SUBJECT: R. E. GINNA NUCLEAR POWER PLANT – FLOOD HAZARD MITIGATION STRATEGIES ASSESSMENT (CAC NO. MF7929; EPID L-2017-JLD-0004)

STAFF ASSESSMENT BY THE OFFICE OF NUCLEAR REACTOR REGULATION
RELATED TO MITIGATION STRATEGIES FOR R. E. GINNA NUCLEAR POWER PLANT
AS A RESULT OF THE REEVALUATED FLOODING HAZARD NEAR-TERM TASK FORCE
RECOMMENDATION 2.1- FLOODING CAC NO. MF7929

Figure 3.1.1-3. Flow velocity at the power block area for the streams and rivers flood-causing mechanism, taken from the licensee letter (Exelon, 2017).

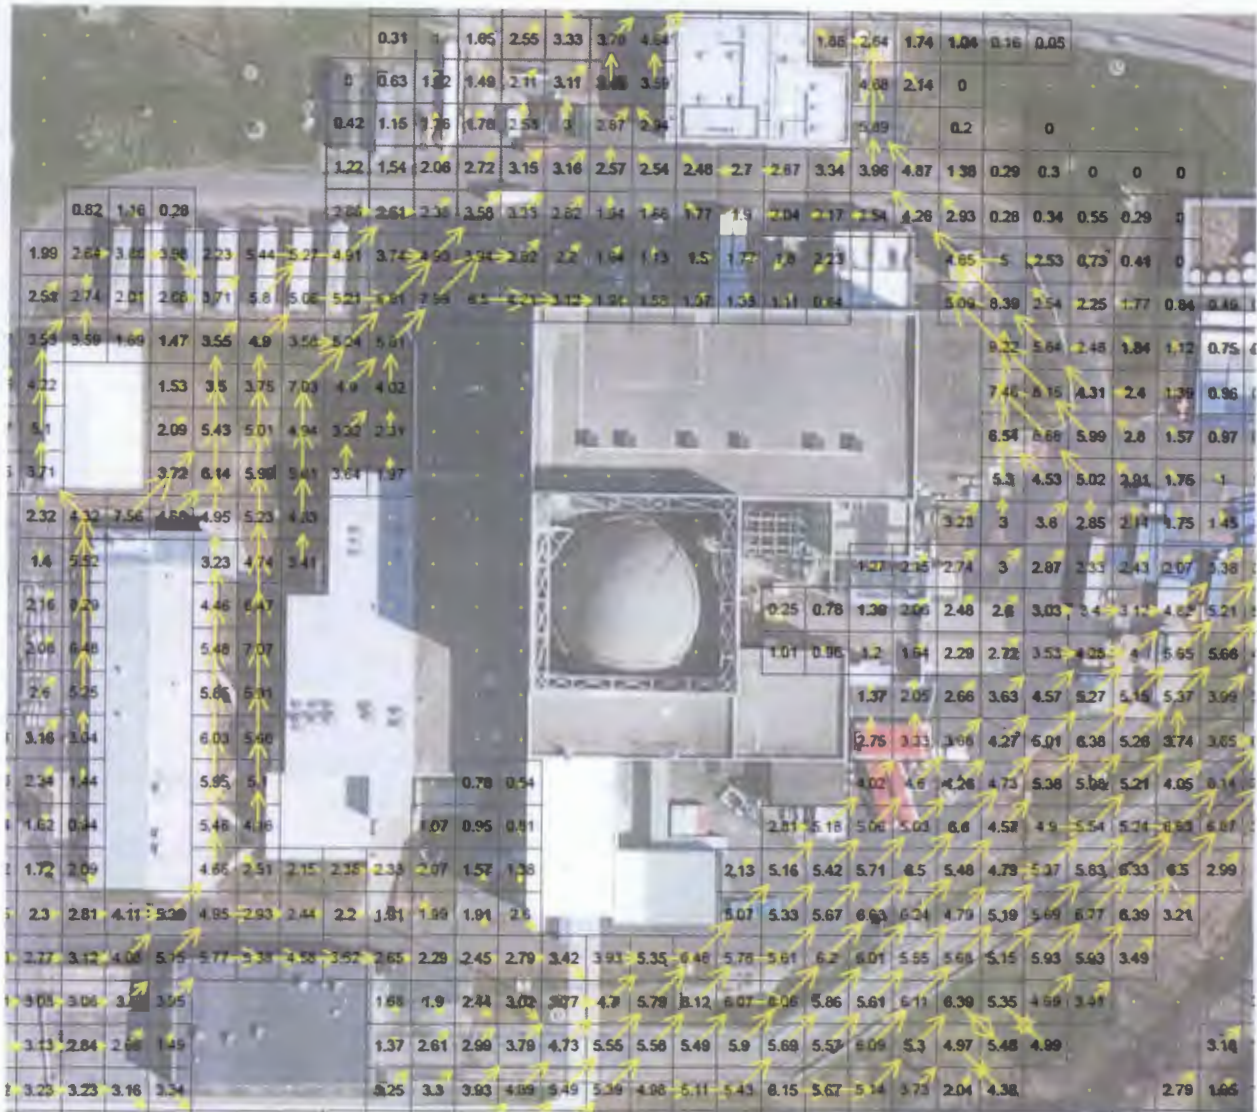
The licensee created rainfall hyetograph (incremental rainfall-time plot) for the contributory Ginna watershed basin using the estimated ssPMP values (Exelon, 2016b). They then used the hyetograph as input into the Hydrologic Engineering Center-Hydrologic Modeling System (HEC-HMS) hydrologic computer model (USACE, 2000) to simulate PMF flow hydrographs for each subbasin. The Ginna HEC-HMS has two subbasins: Mill Creek and Deer Creek (Figure 3.1.1-1). They then applied FLO-2D (FLO-2D, 2013) to evaluate detailed onsite flood hazards (i.e.,

flood level, inundation depth, flow velocity, etc.) for the basin PMF event which would overflow the onsite stream channel and inundates the power block area (see Figures 3.1.1-2, 3.1.1-3, 3.1.1-4).
